ADDENDUMS / REVISIONS	
ADDENDUM NO. $\Delta$	REVISED GRADING
5/17/2013, RLS

**INDIAN RIVER INLET  
PARK ENHANCEMENTS**

**GRADES AND GEOMETRICS  
GRADING PLAN  
(BASE BID)**

<b>GG22-AA</b>
SHEET NO.
65
TOTAL SHTS.
282

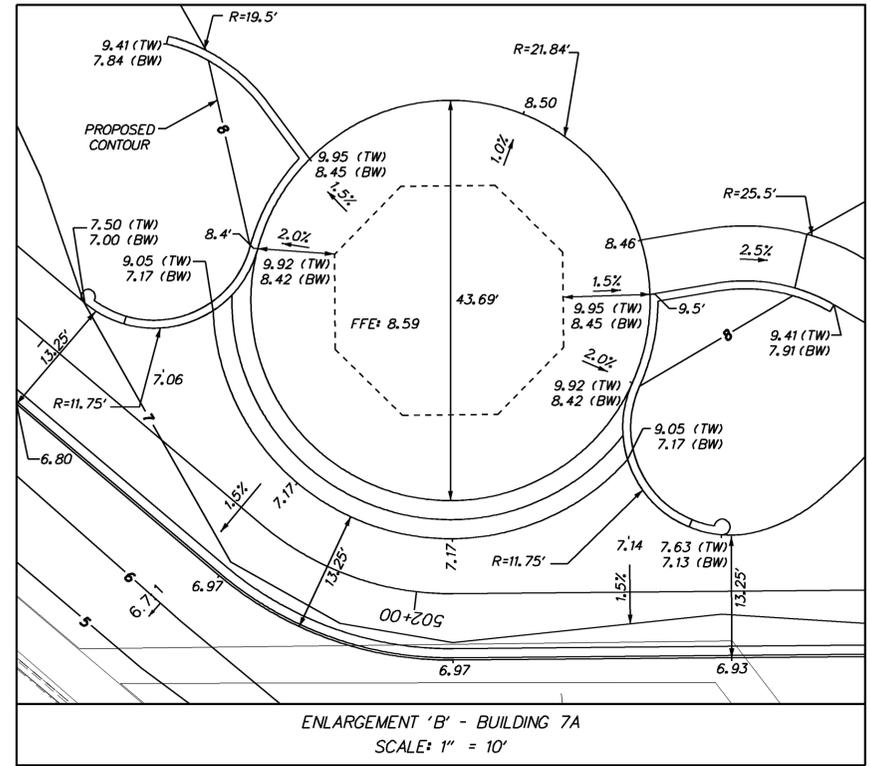
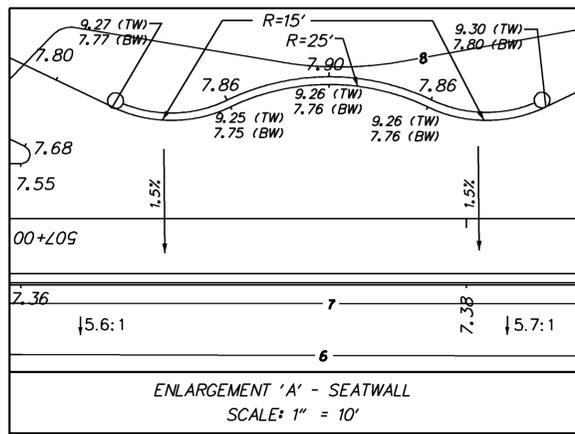
ADDENDUMS / REVISIONS	
ADDENDUM NO. $\Delta$	REVISED GRADING
5/17/2013, RLS

<b>GG23-AA</b>
SHEET NO.
66
TOTAL SHTS.
282

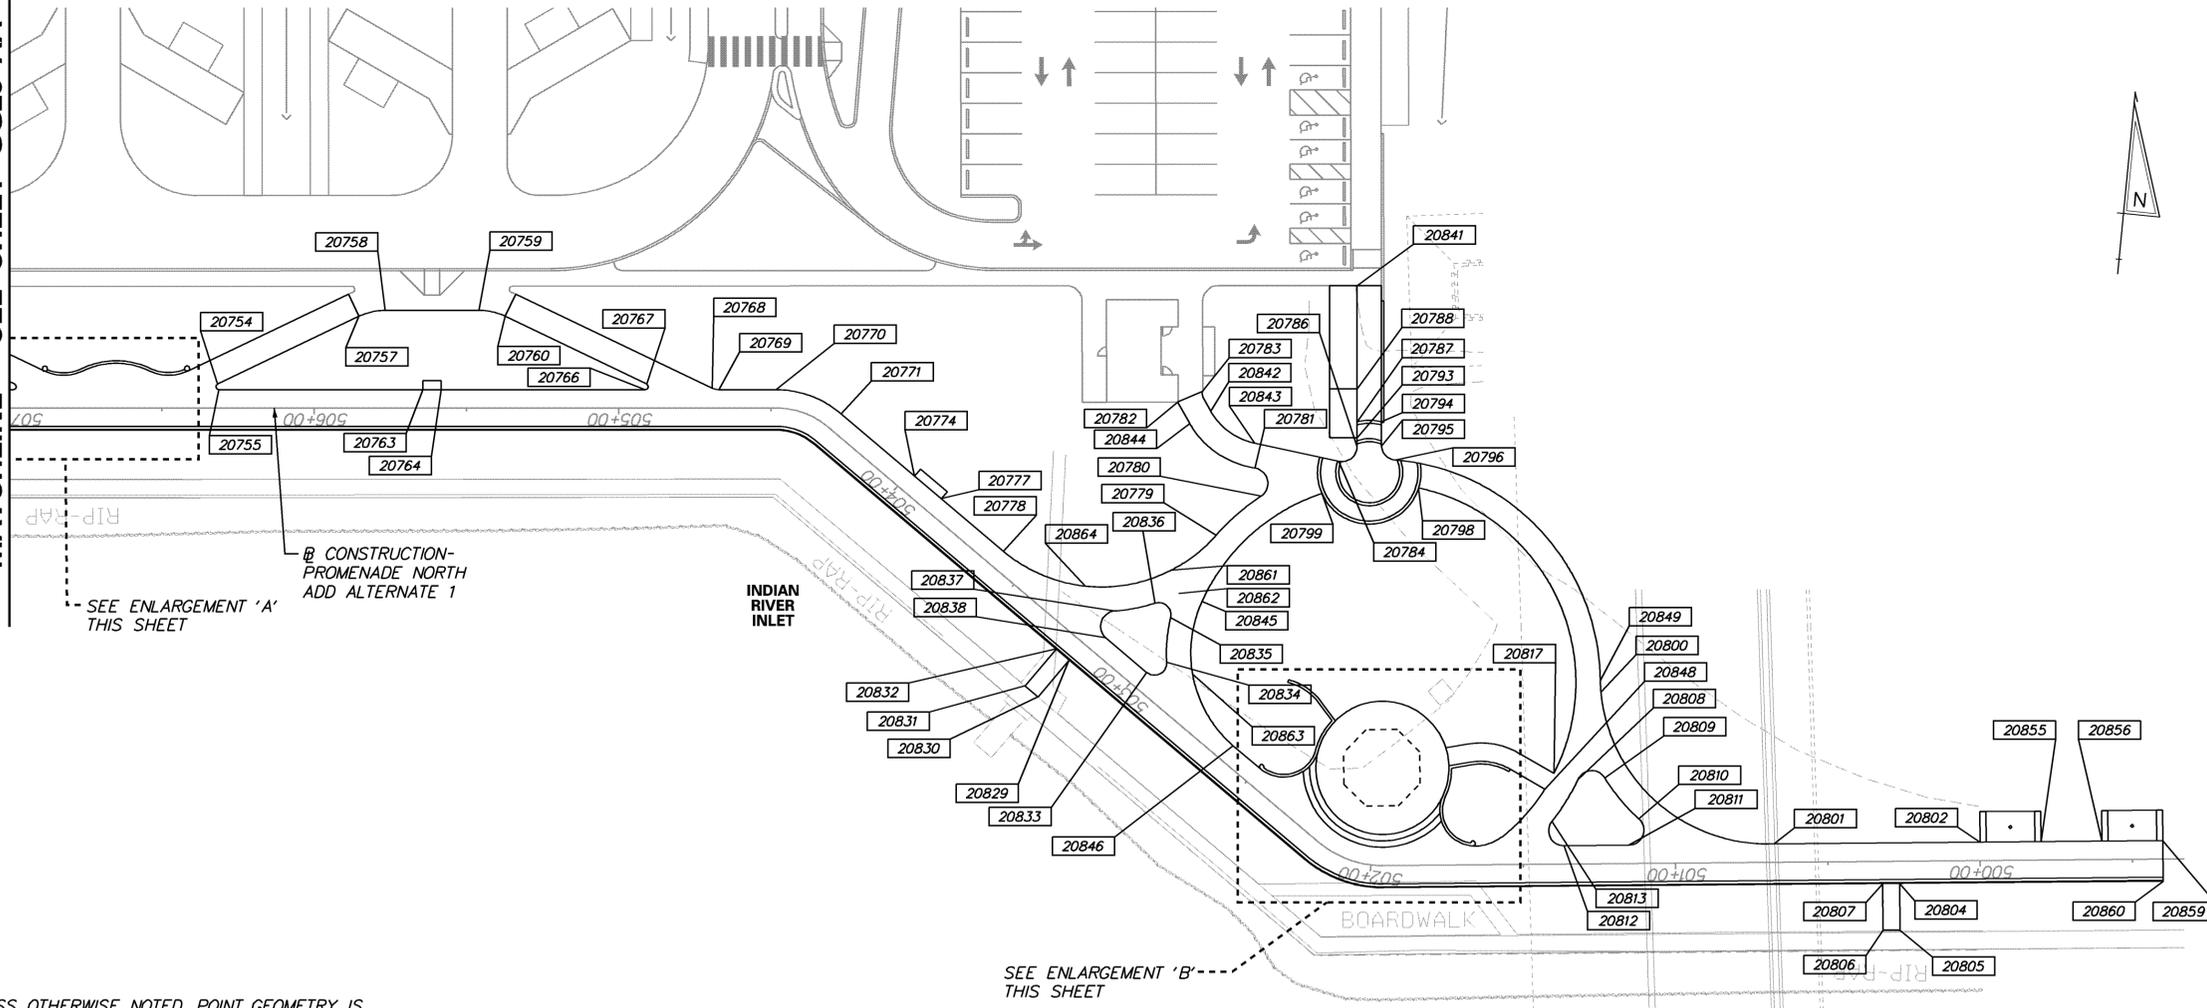
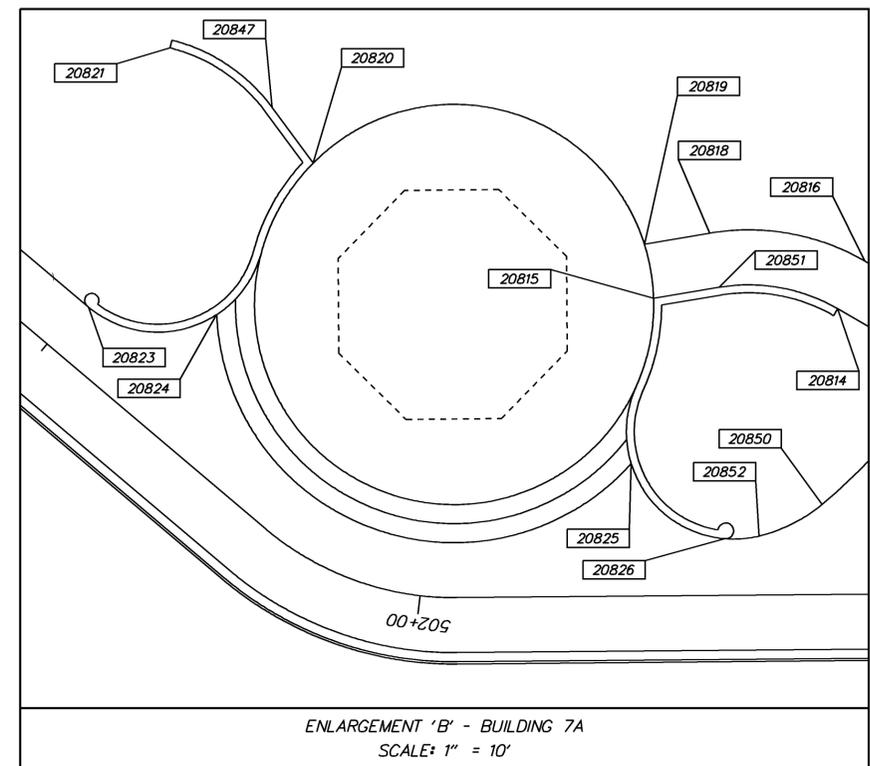
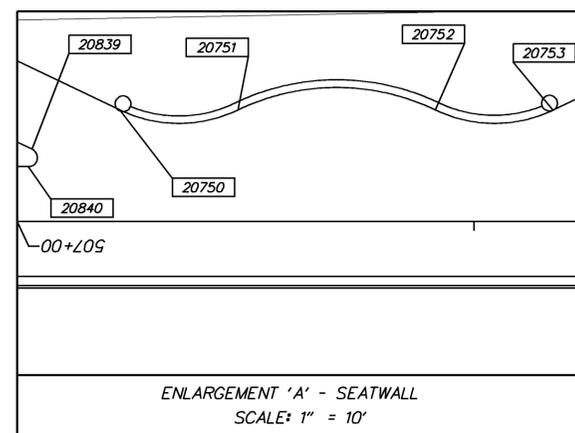
ADDENDUMS / REVISIONS	
ADDENDUM NO. $\Delta$	REVISED ELEVATIONS
5/17/2013, RLS

<b>E7</b>
SHEET NO.
159
TOTAL SHTS.
282

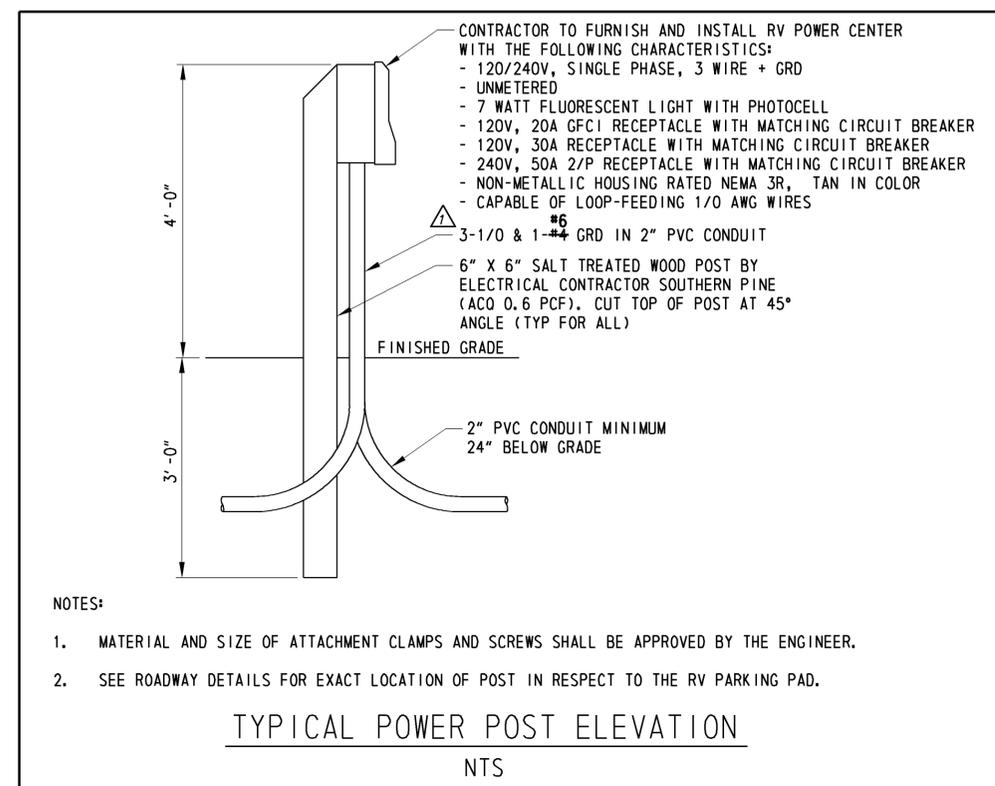
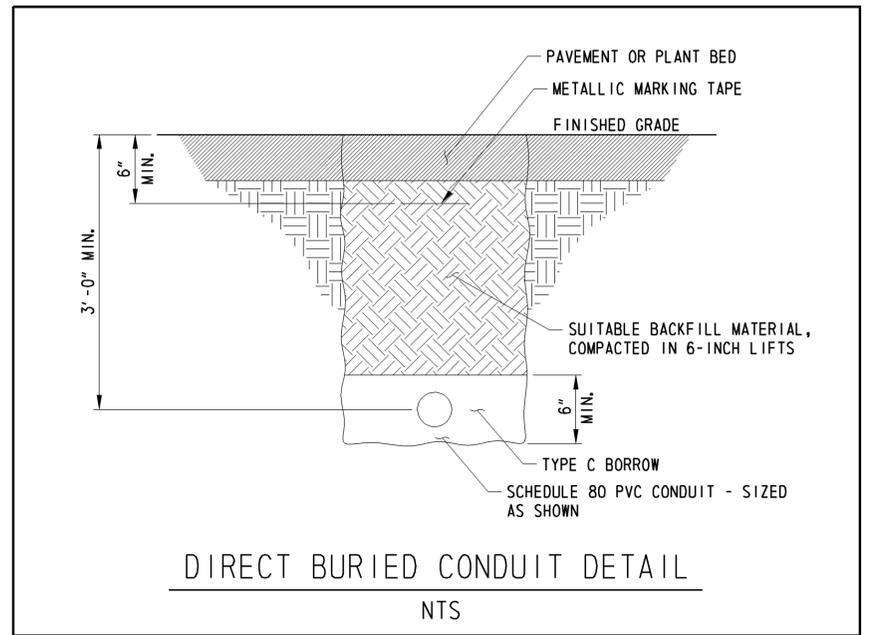
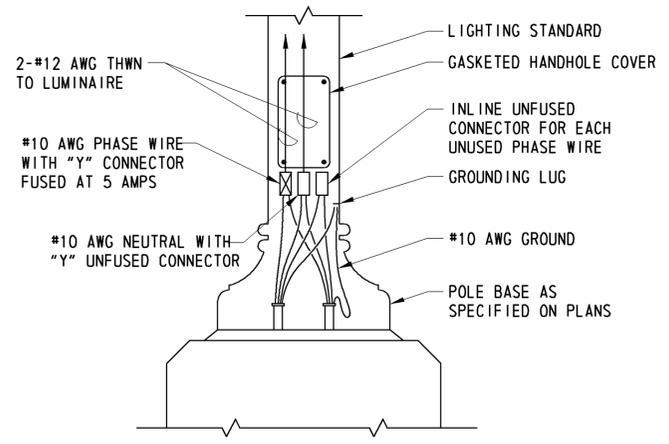
ADDENDUMS / REVISIONS	
ADDENDUM NO. $\Delta$	REVISED NOTE
5/17/2013, RLS

- NOTES:
- MATERIAL AND SIZE OF ATTACHMENT CLAMPS AND SCREWS SHALL BE APPROVED BY THE ENGINEER.
  - SEE ROADWAY DETAILS FOR EXACT LOCATION OF POST IN RESPECT TO THE RV PARKING PAD.

<b>UTILITY RELOCATION PLAN</b> (WATER, SEWER, VERIZON)	
UT01	SHEET NO.
	168
	TOTAL SHTS.
	282

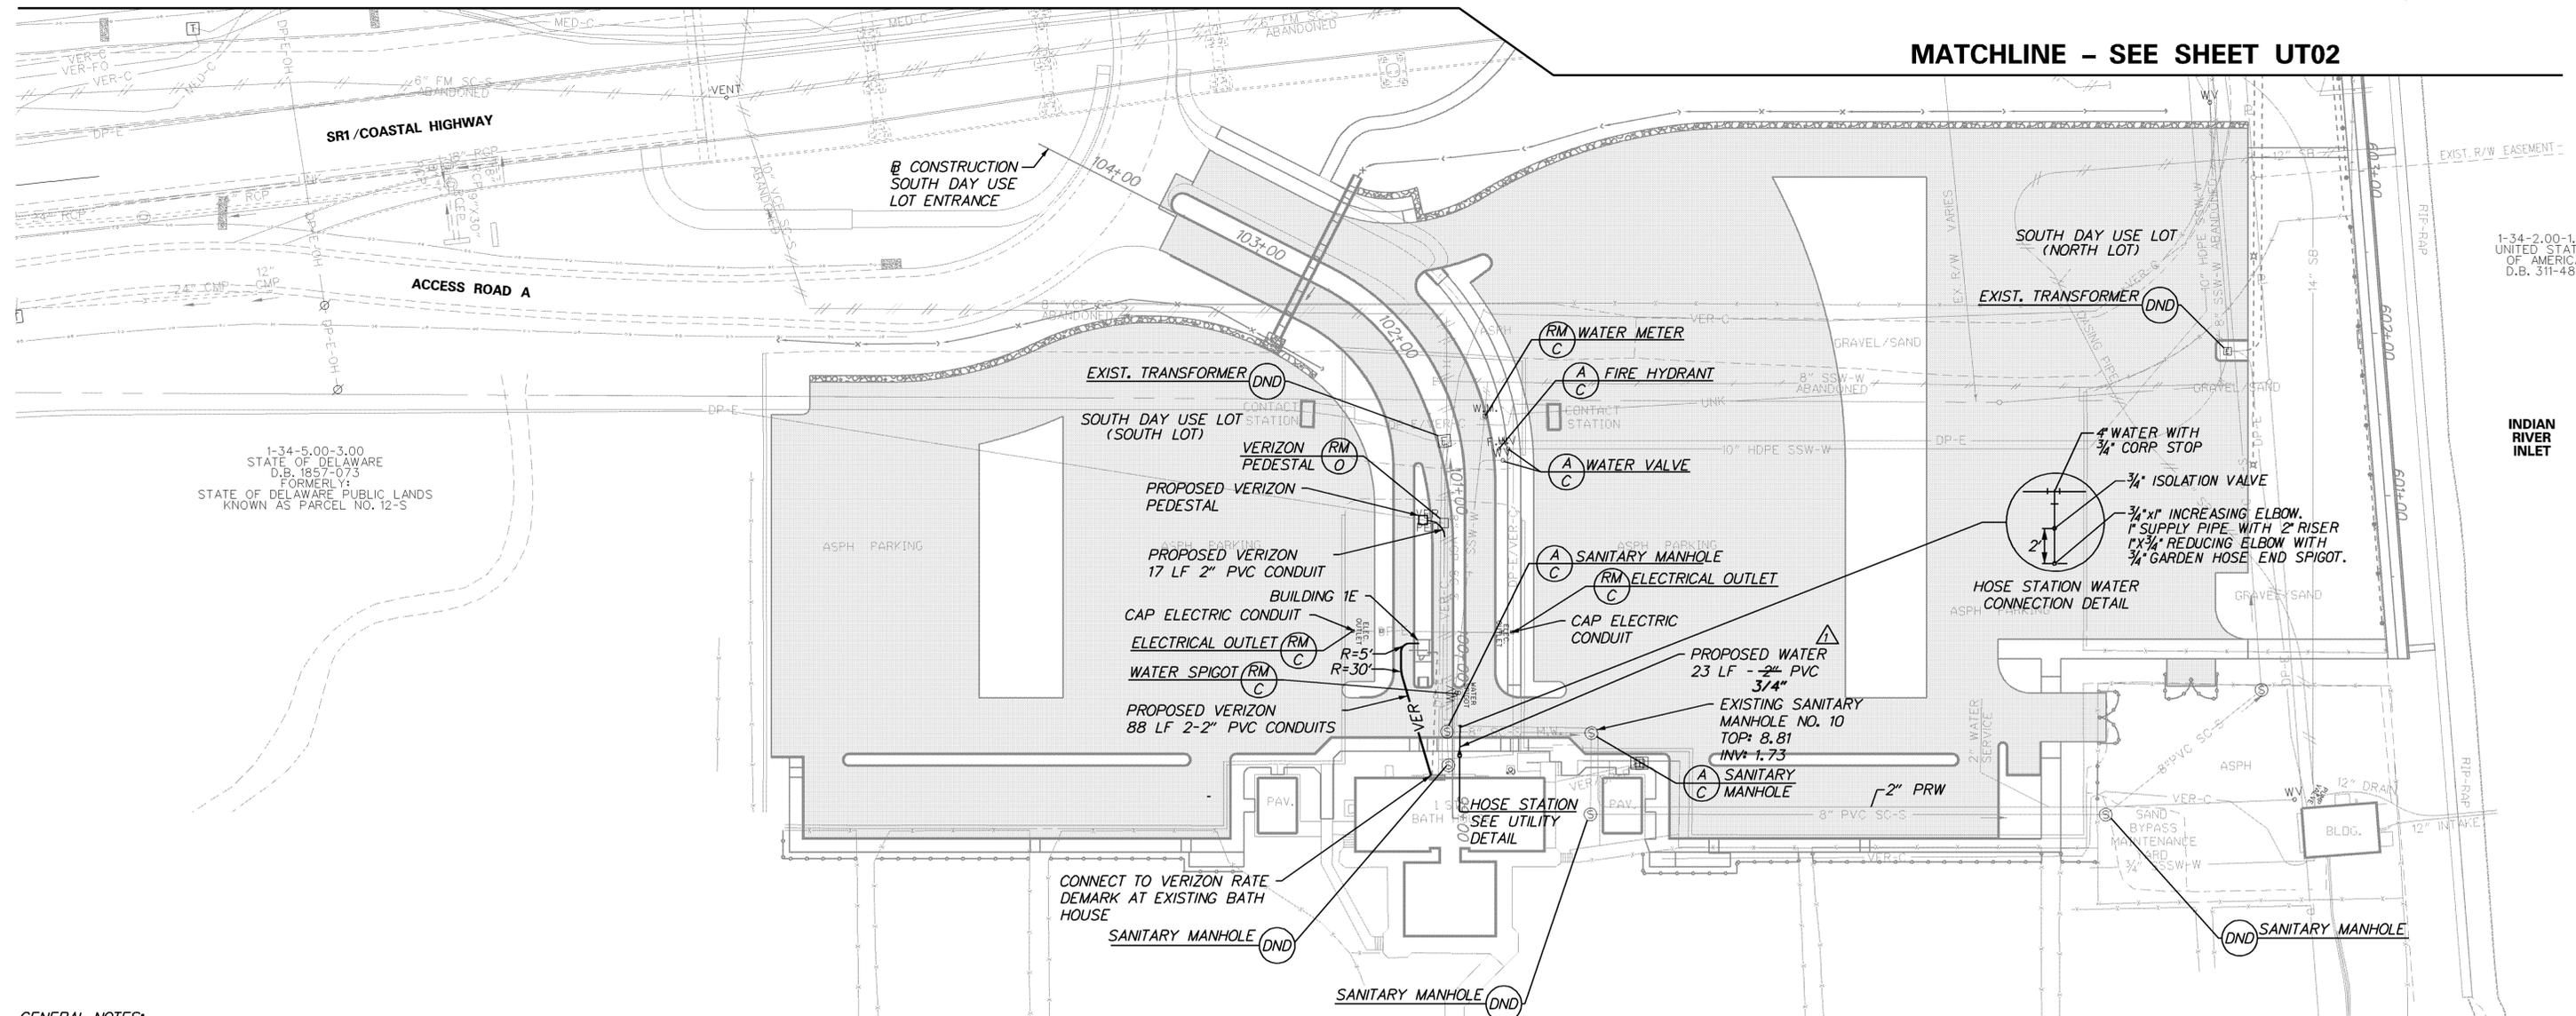
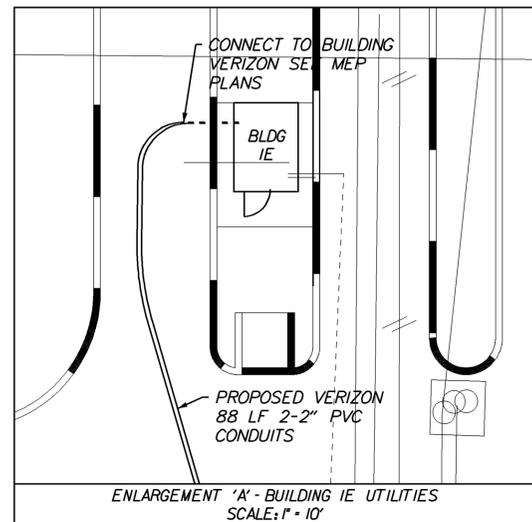
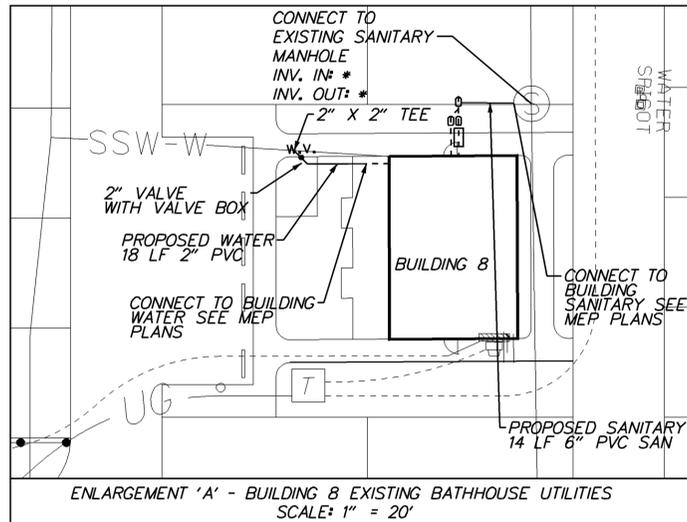
ADDENDUMS / REVISIONS	
ADDENDUM NO. $\Delta$	REVISED NOTE
5/17/2013, RLS

8. SEE UTILITY RELOCATION DETAILS FOR VERIZON DIRECT BURIED CONDUIT DETAIL.
